MICROCHIP PIC18F2420/2520/4420/4520

PIC18F2420/2520/4420/4520 Rev. B3 Silicon Errata

The PIC18F2420/2520/4420/4520 Rev. B3 parts you have received conform functionally to the Device Data Sheet (DS39631E), except for the anomalies described below. Any Data Sheet Clarification issues related to the PIC18F2420/2520/4420/4520 will be reported in a separate Data Sheet errata. Please check the Microchip web site for any existing issues.

FIGURE 1: SCK PULSE VARIATION USING TIMER2/2

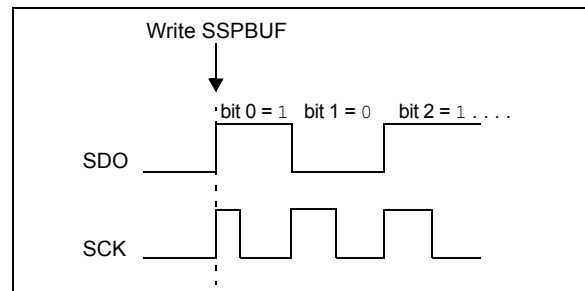
When the SPI is using Timer2/2 as the clock source, a shorter than expected SCK pulse may occur on the first bit of the transmitted/received data (Figure 1).

To avoid producing the short pulse, turn off Timer2 and clear the TMR2 register, load the SSPBUF with the data to transmit and then turn Timer2 back on. Refer to Example 1 for sample code.
